City of Streetsboro
Planning and Zoning Commission

PRELIMINARY PLAN FOR THE VILLAS AT BOULDER CREEK

RE: Major Subdivision Preliminary Plan Review - Villas at Boulder Creek

Villas at Boulder Creek Preliminary Plan Review

TITLE SHEET	
CONTRACT NO.	
23095	
SHEET	OF
01	07

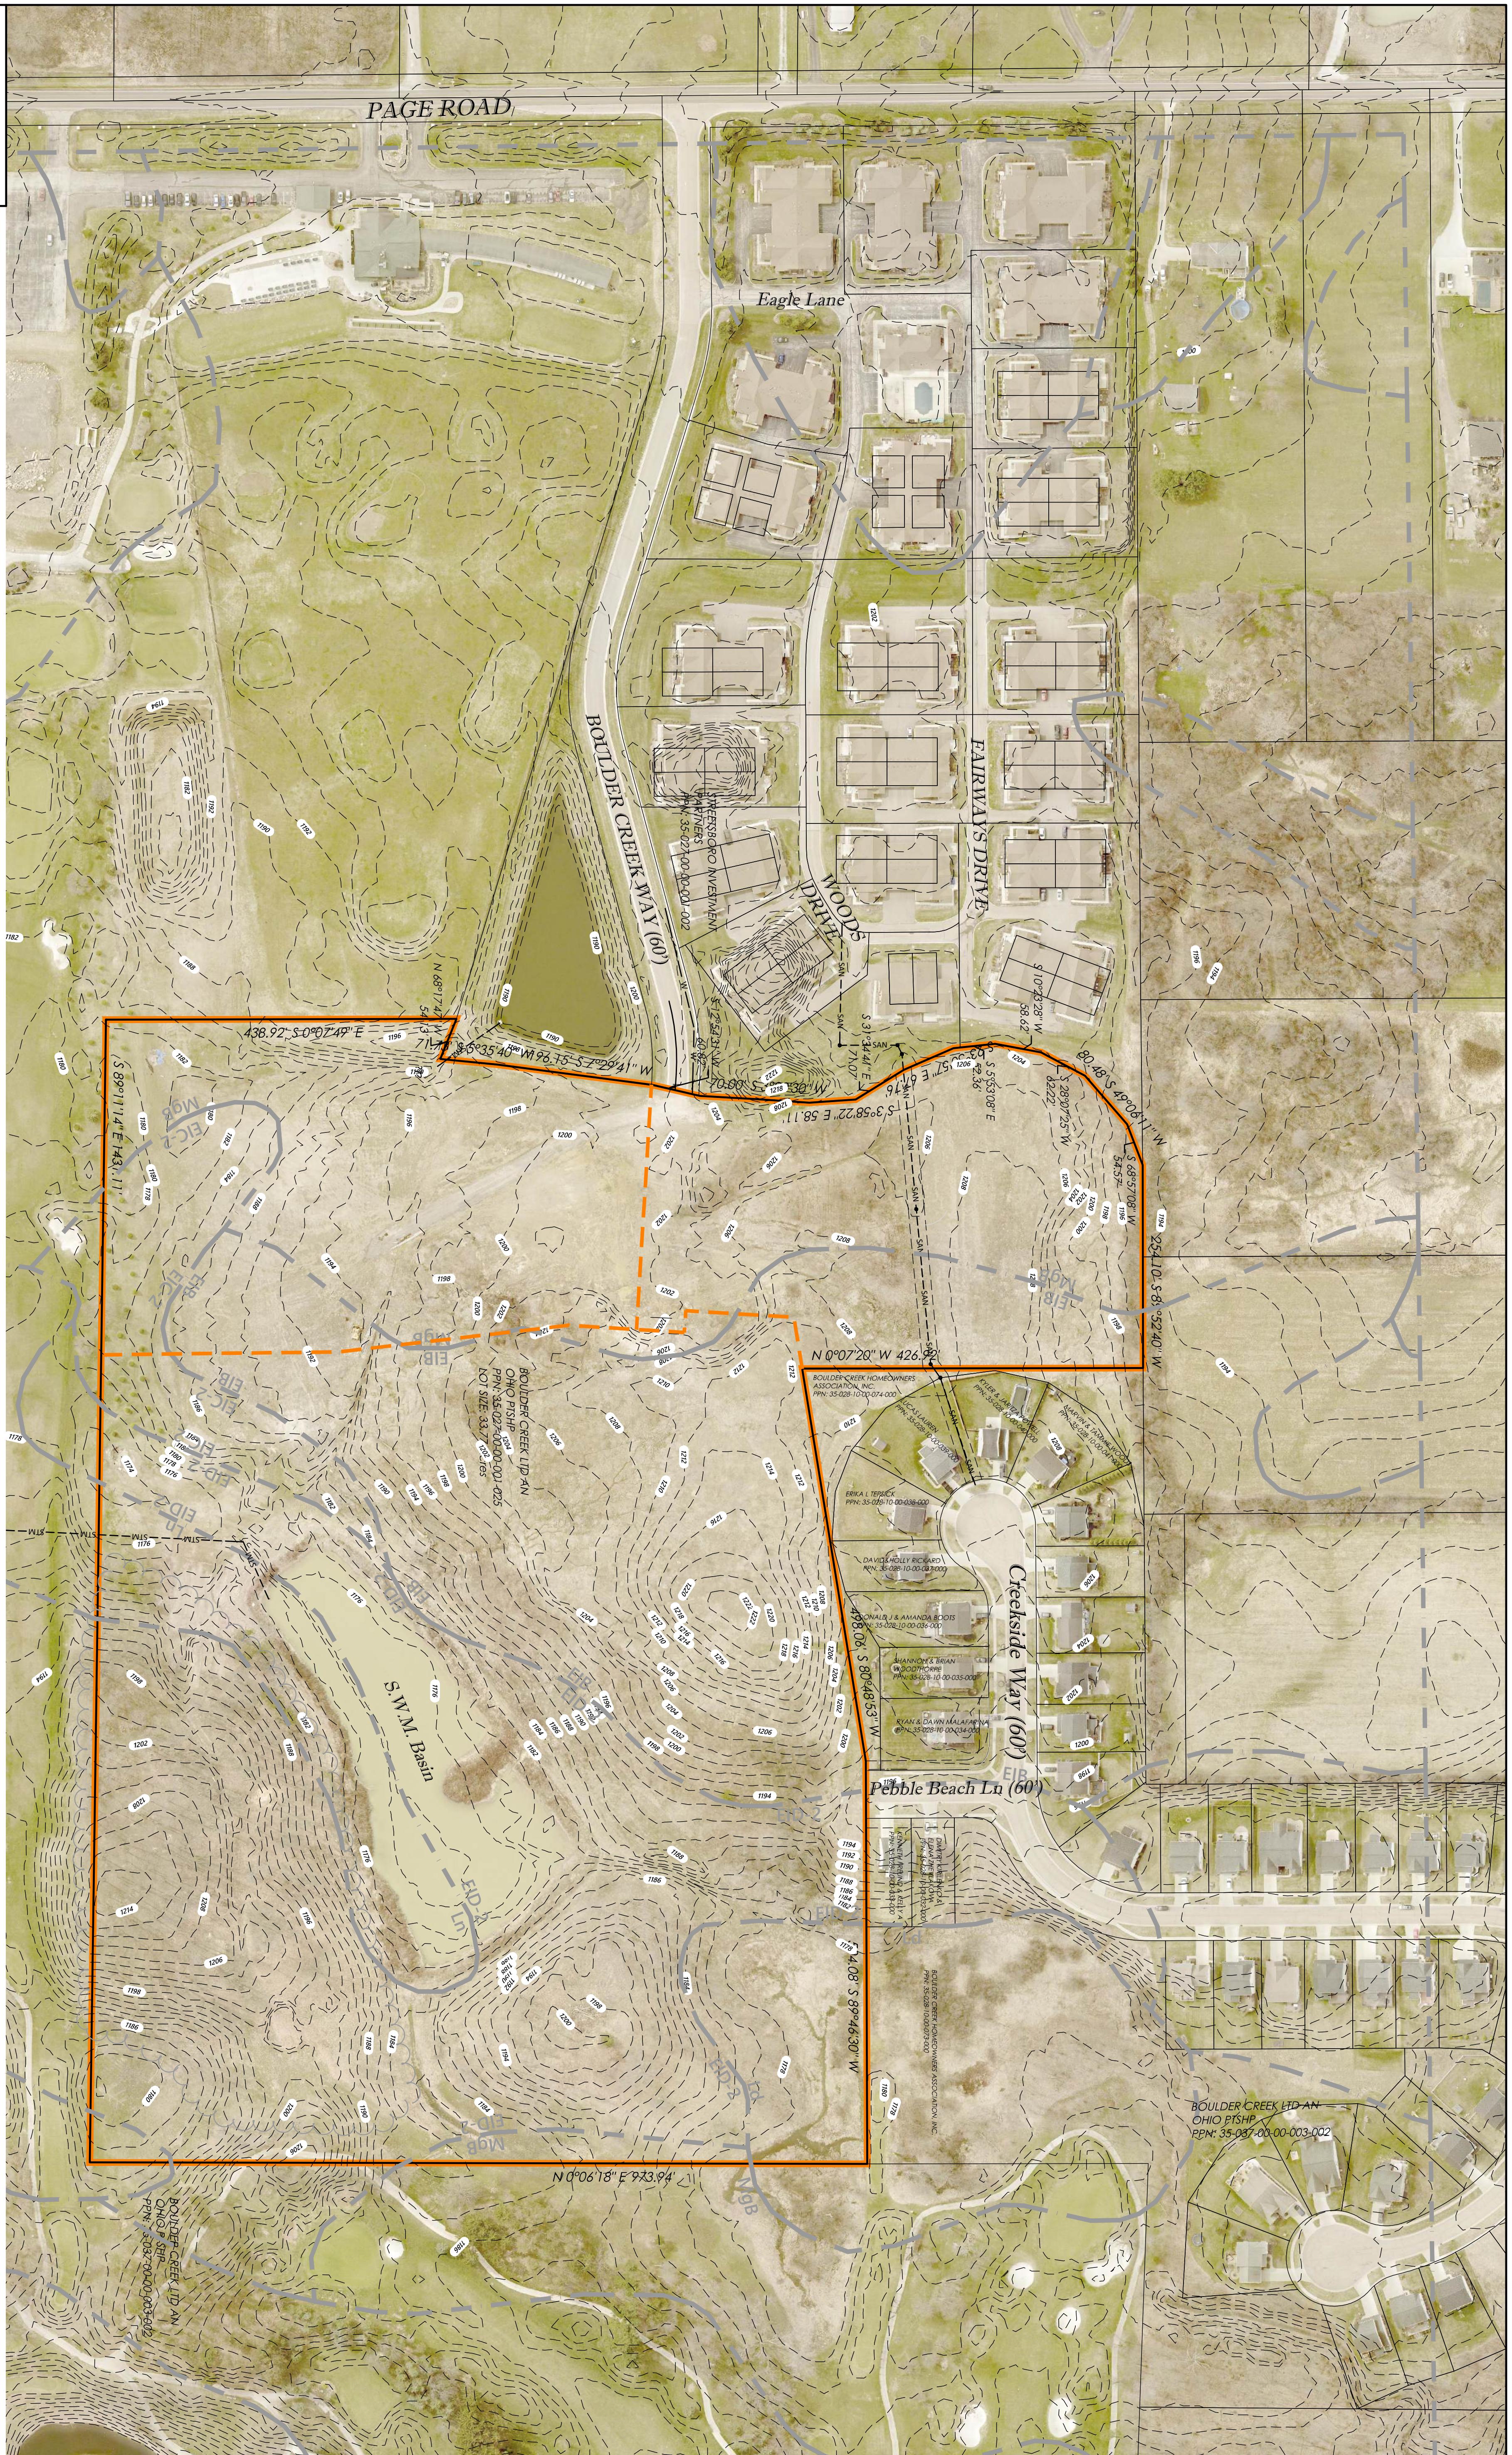
* There is 2.5 Acres that is unaccounted for and is assumed to be on over a portion of the Golf Course/Driving Range

3. The title page has an overall density table that has a disclaimer stating that there are 2.5 acres that are unaccounted for and assumed to be a part of the golf course/driving range. The applicant should clear up this discrepancy and provide explanation.

3. That the applicant clarifies the discrepancy of 2.5 acres that are unaccounted for and provide explanation.
4. That the applicant relabels Private Road A as Private Road A (North) and Private Road A (South) accordingly.

DEVELOPMENT PLAN

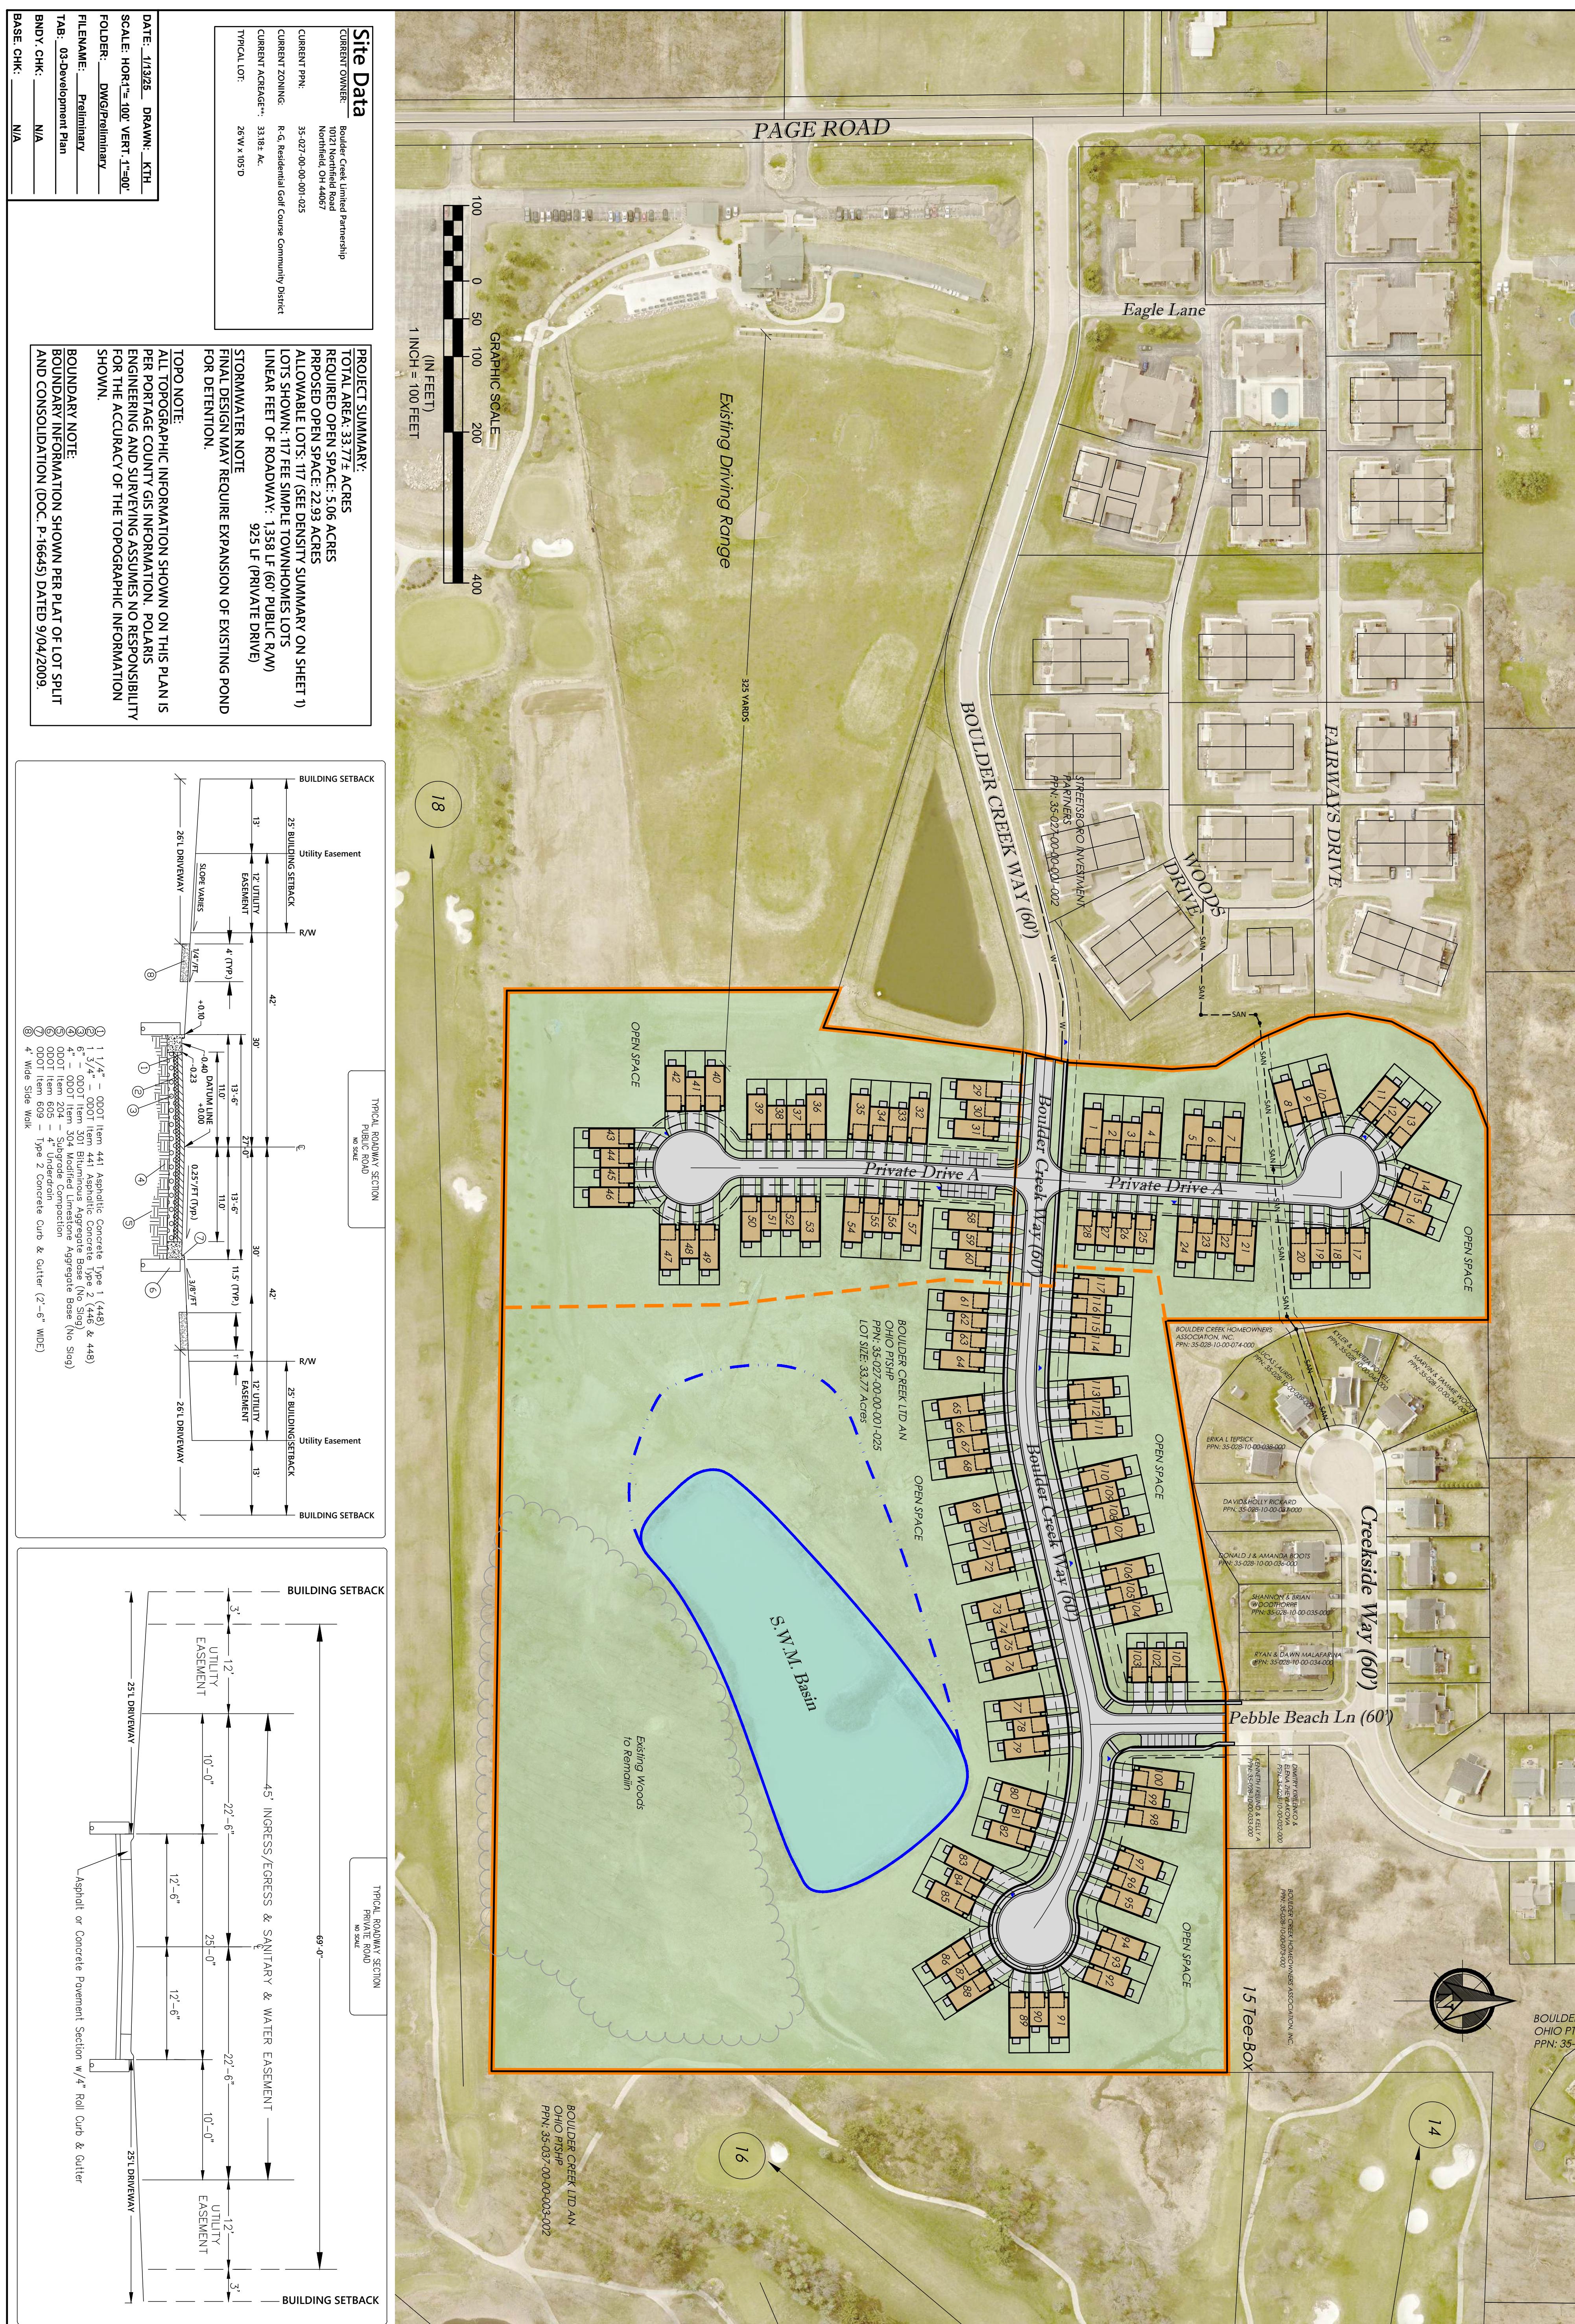
Sheet 3 – Development Plan

18. Will barrier netting be installed at the back of the existing driving range as part of this project to protect the homes along Private Drive A?

UTILITY & TOPOGRAPHIC PLAN PHASE 3

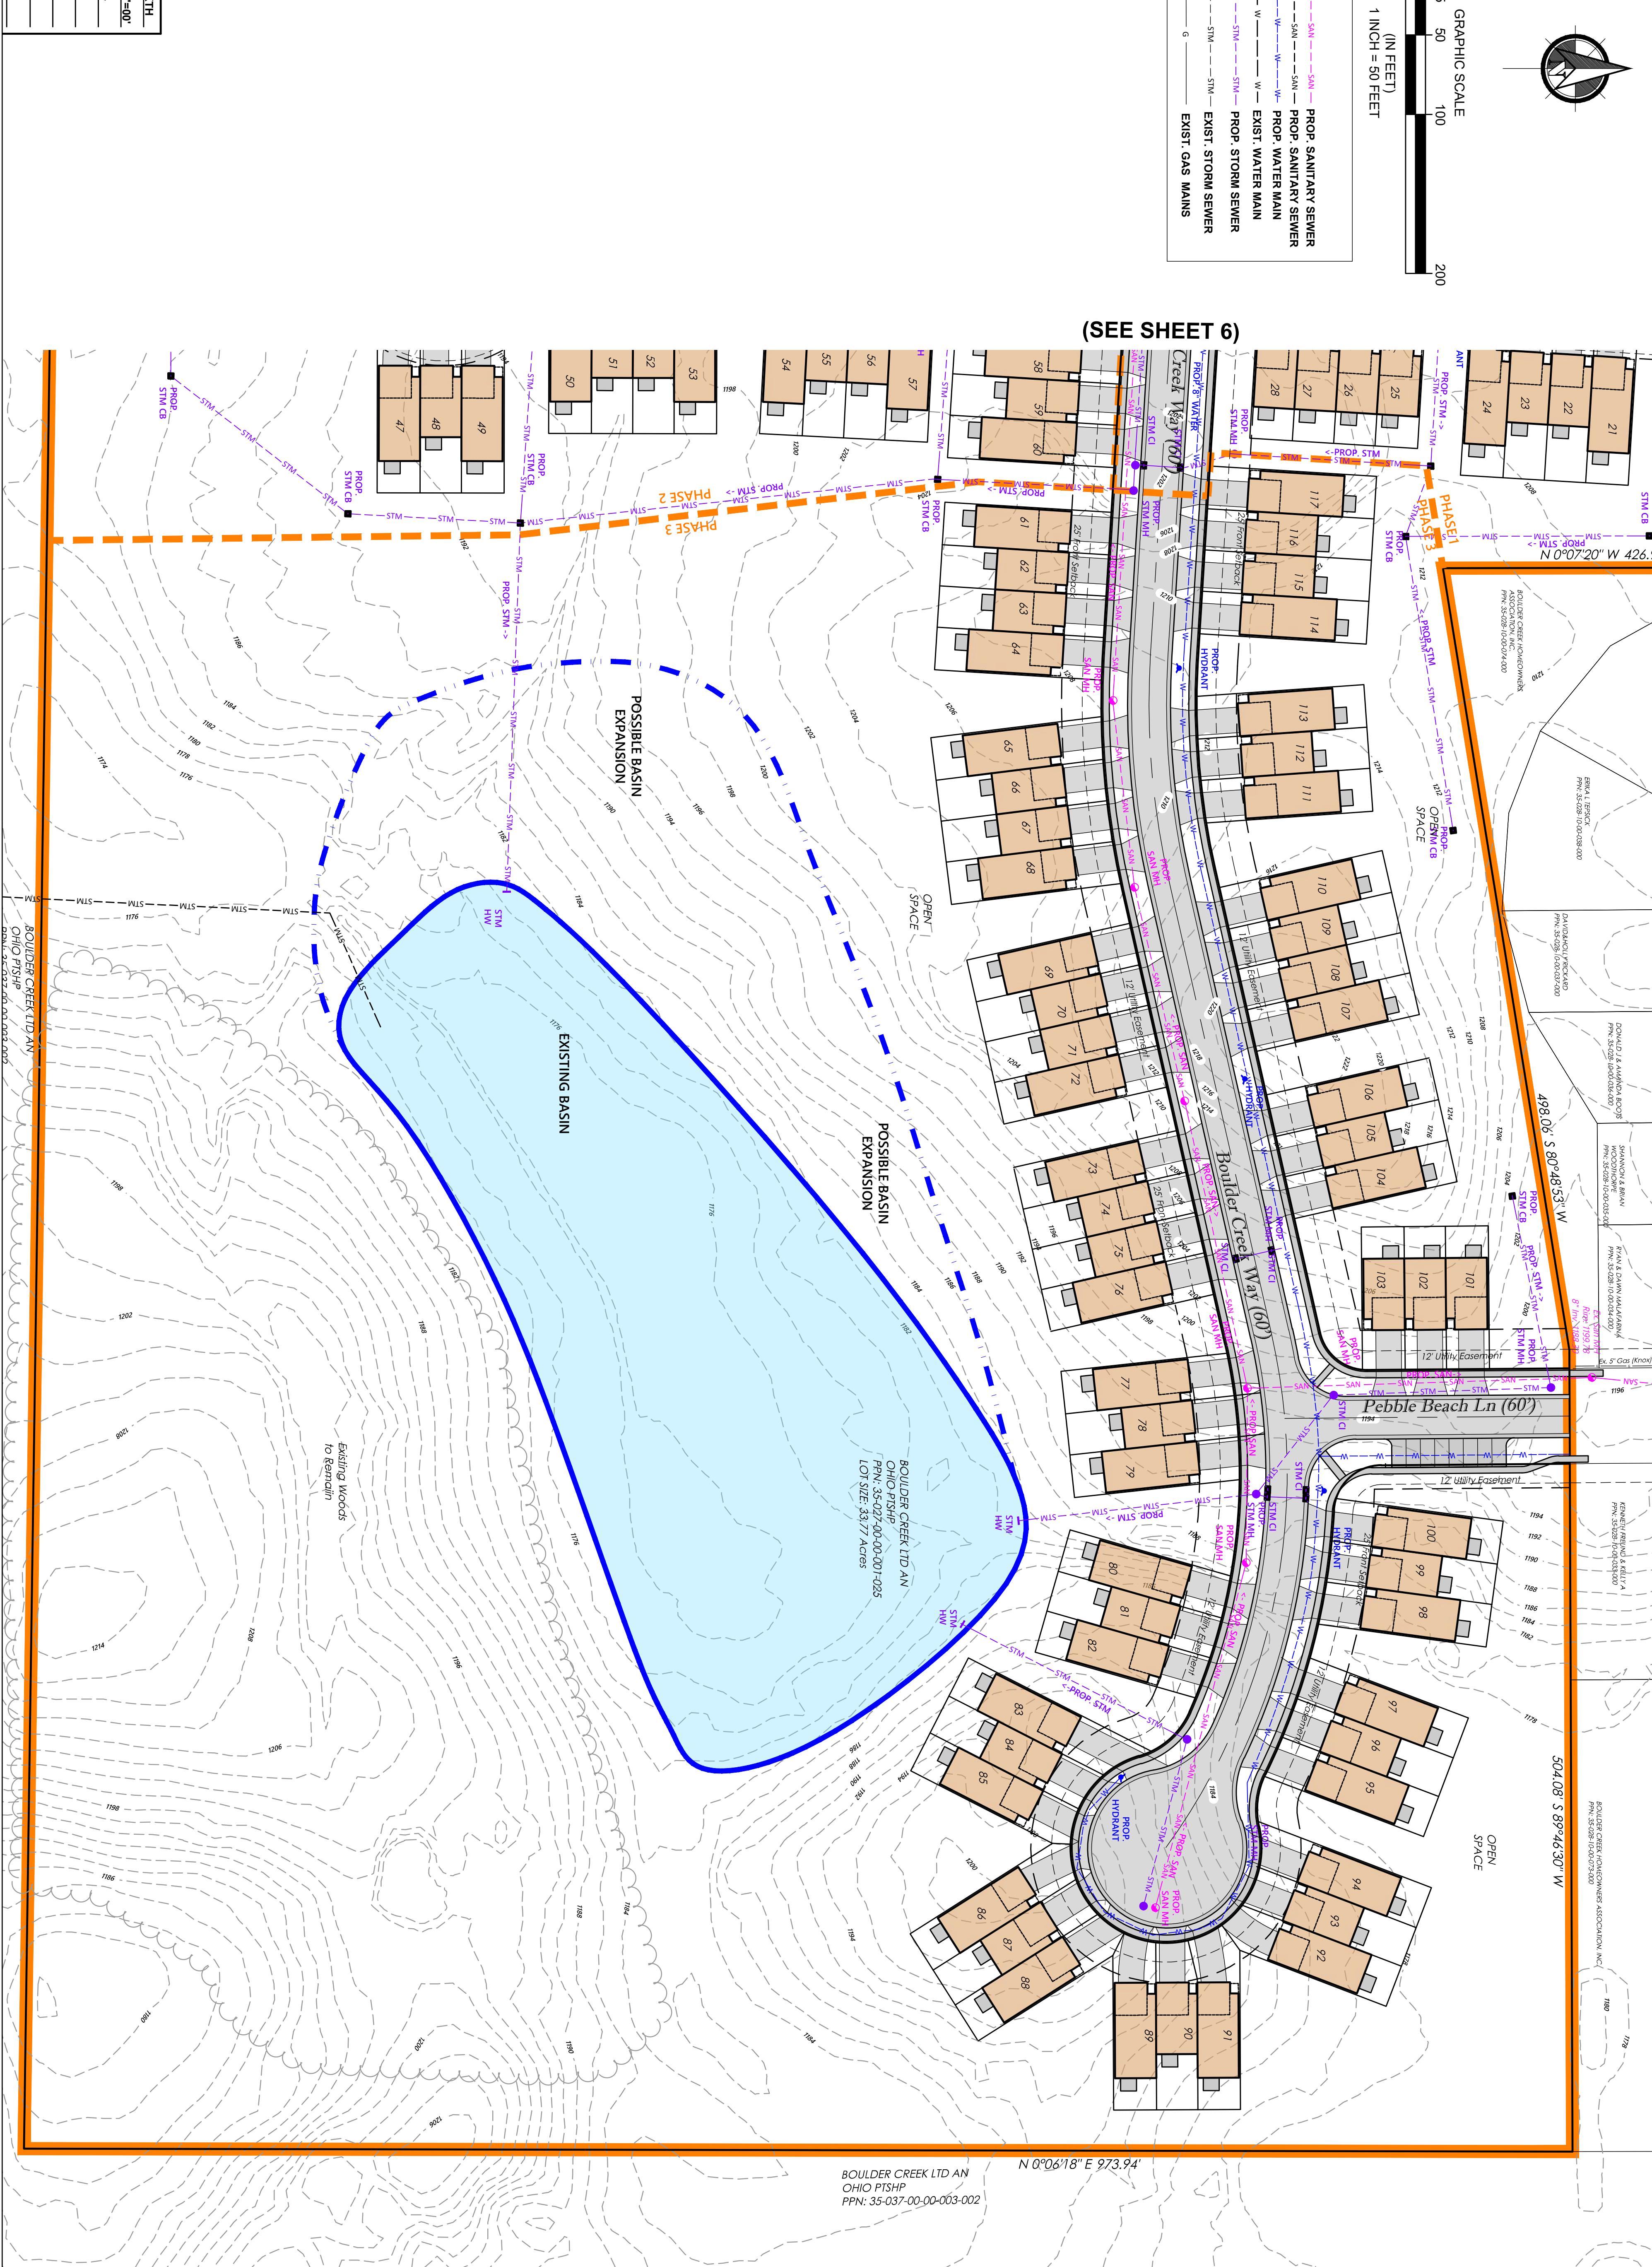
Sheet 7 – Utility & Topographic Plan Phase 3

19. Show the existing sanitary and water mains on Pebble Beach Lane and show the location of the tie-in for the proposed mains.
